# Response to Submissions

New Wee Waa High School  
SSD - 21854025

March 2022

**Figure 1** Amended site layout showing relocation of parking and Indigenous cultural centre

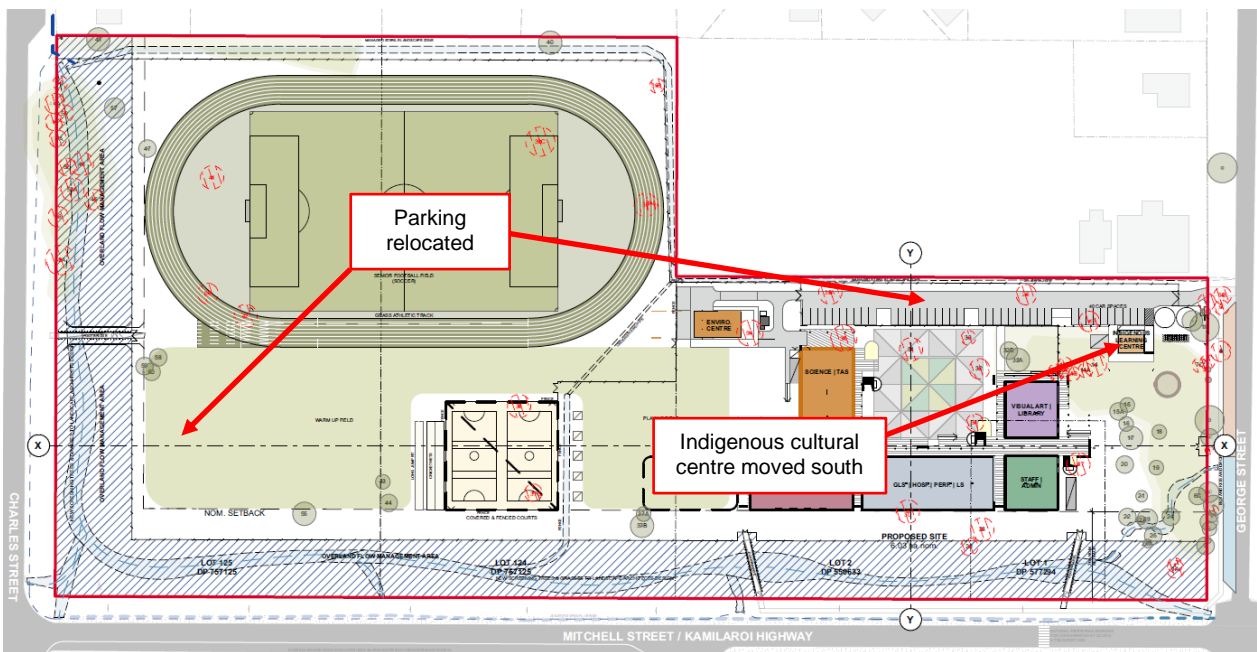
In response to concerns raised by the school user group and SINSW internal technical stakeholders, the parking proposed at the western boundary of the site has been relocated to be adjacent to the internal access road from George Street. There is no change to the total number of parking spaces proposed (40 spaces). All parking is now consolidated in one single area.

To accommodate the relocated parking, two-way access and reversing from spaces, the internal access road has also been increased in width. The Indigenous cultural centre has also been shifted to the south to accommodate the additional road.

**Figure 2 Proposed public domain plan**

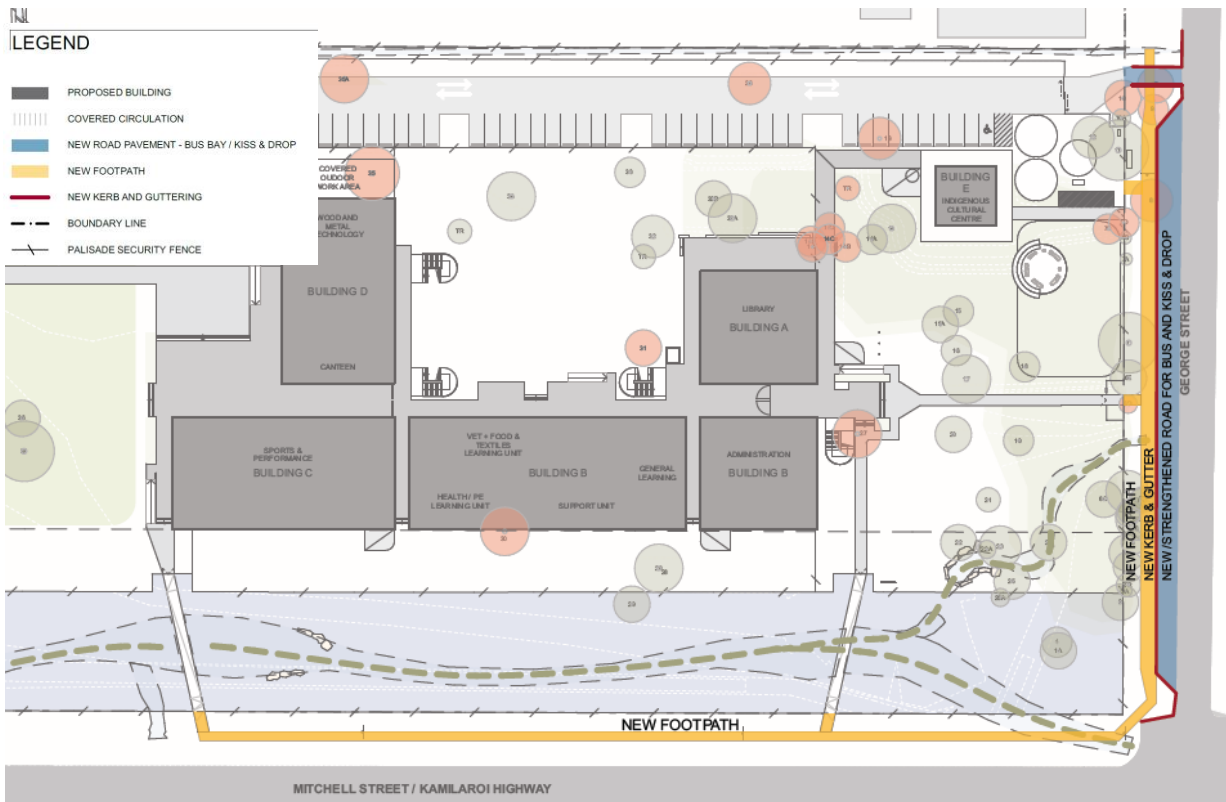
A Public Domain Plan has been prepared by SHAC and provided at Appendix B. The plan shows the extent of new footpath, road strengthening and kerb and gutter that will be delivered as part of the proposal. As shown in Figure 2, a new public footpath will be provided along the George Street frontage, continuing around to Mitchell Street and terminating at the western pedestrian access bridge. New kerb and gutter will be installed along the George Street frontage and new road pavement will be installed to accommodate the bus zone and kiss-and-drop along George Street.

**Figure 3** Indicative opportunities for public art – elevation

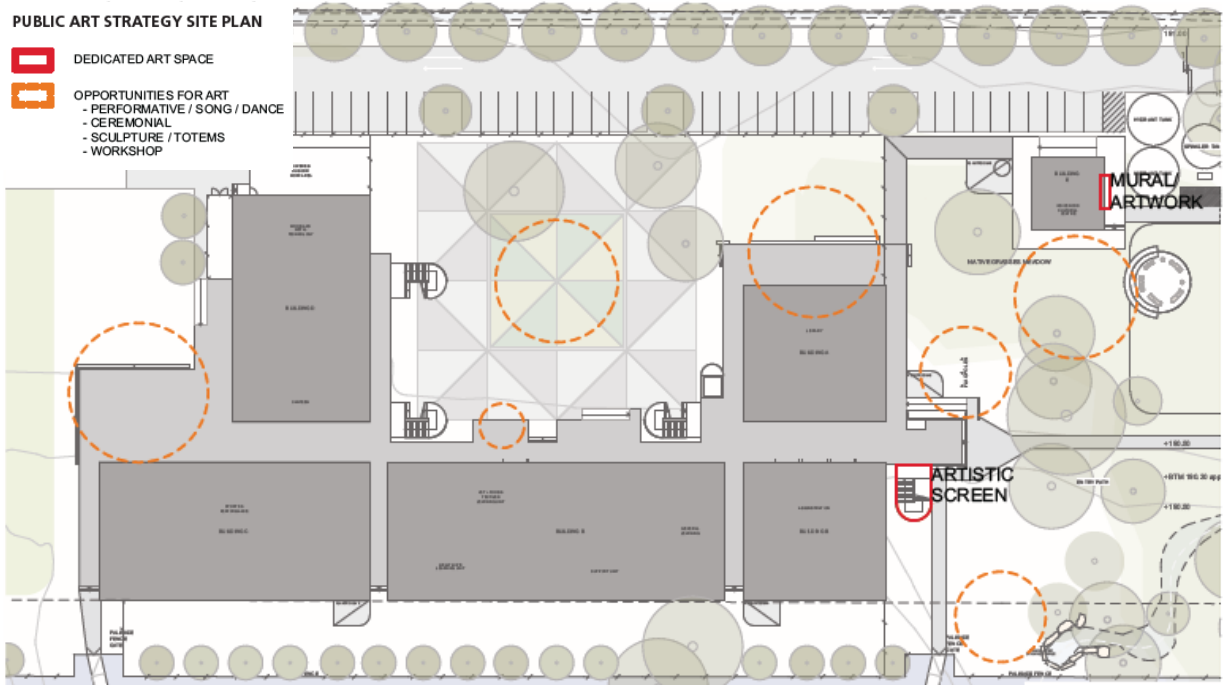
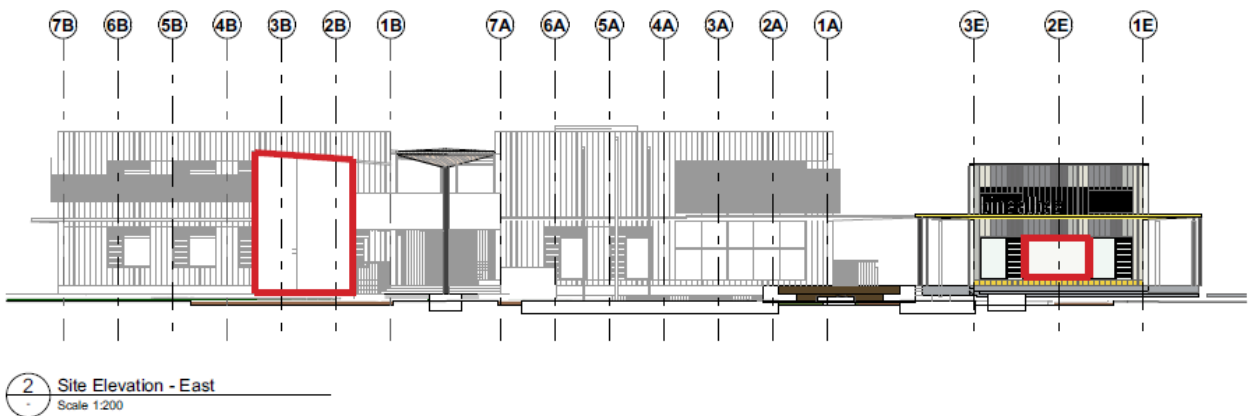
Clarify the details of the public art strategy for the site and likely location(s) for installation(s).	DPE	The Design Report (Appendix C) has been updated to include an indicative Public Art Strategy at pages 91-95. Opportunities identified for public art include: <ul style="list-style-type: none"> <li>• A dedicated mural or artwork on the eastern façade of the Indigenous cultural centre.</li> <li>• A dedicated artwork on the architectural screening adjacent to the main school entry.</li> <li>• Spaces that can accommodate performative song/dance, ceremonial, sculptural/totem, and workshop style public art during the ongoing operation of the school.</li> </ul> Further detail of the public art strategy and the installation/programming of public art can be provided prior to operation of the school. No changes to proposed mitigation measures are required.

Indicative opportunities and locations for public art have been identified as shown at Figure 3 and Figure 4. Key opportunities include a public artwork on the architectural screening adjacent to the main school entrance, as well as another public artwork or mural on the eastern façade of the Indigenous cultural centre. For further detail of potential content, programming and commissioning, refer to pages 91-95 of the Design Report (Appendix C). Public art will be further developed in consultation with the school user group and community and will be implemented upon completion as well as into the operational phase of the project.

**Figure 5** Visual privacy and sightline analysis

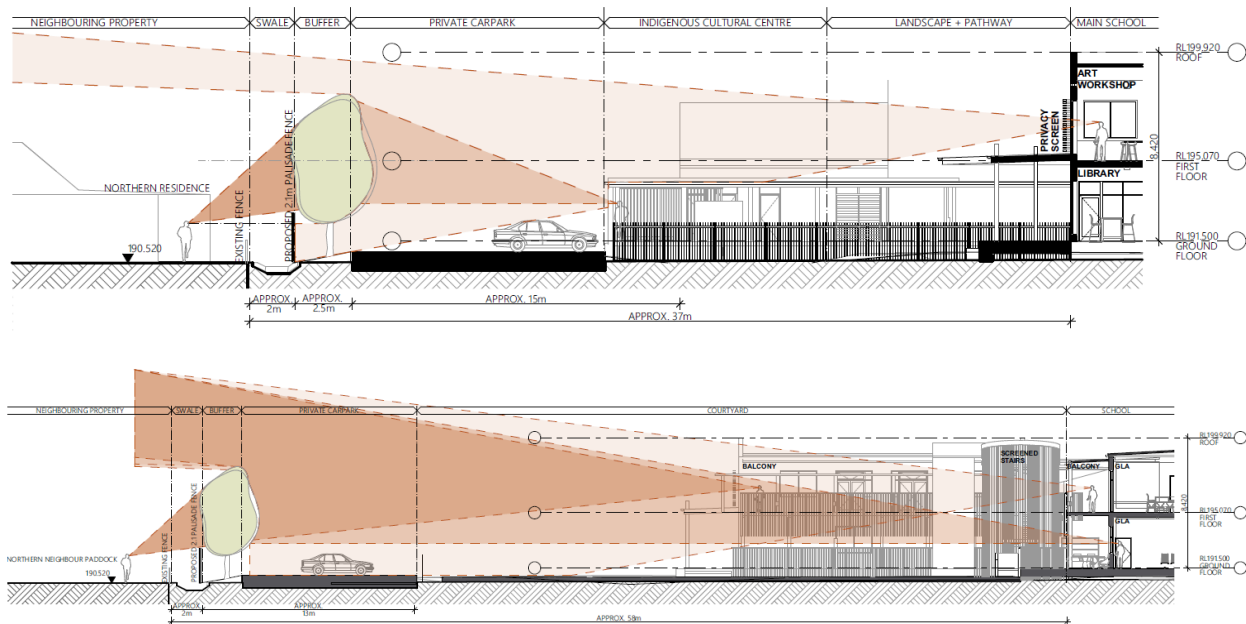
Visual privacy and overlooking	<ul style="list-style-type: none"> <li>SE-32931803</li> <li>SE-32838276</li> </ul>	<p>As described in 3.1.4, a visual privacy and sight-line analysis is provided at Appendix B. The analysis demonstrates that the proposed tree planting (now Coolibah where previously Chinese Elms), in combination with the fencing and separation to the neighbouring site, provide an appropriate level of visual privacy with no direct overlooking to the residence possible. No changes to proposed mitigation measures are required.</p>

Project architects SHAC have undertaken a visual privacy and sight-line analysis at Appendix B. The analysis considers north-south sections taken near the adjoining residence at 41 George Street. The analysis shows the amended boundary interface, tree planting and fencing as described at Section 1.1.1 of this report. Excerpts from the analysis are shown at Figure 5. The analysis demonstrates that the proposed tree planting (now Casuarina where previously Elms), in combination with the fencing and separation to the neighbouring site, provide appropriate visual privacy with no direct overlooking to the residences. Consultation with the neighbour at 41 George Street has been undertaken and they have agreed in-principle to the proposed fencing and landscaping arrangement, pending further confirmation and a private agreement with DoE.
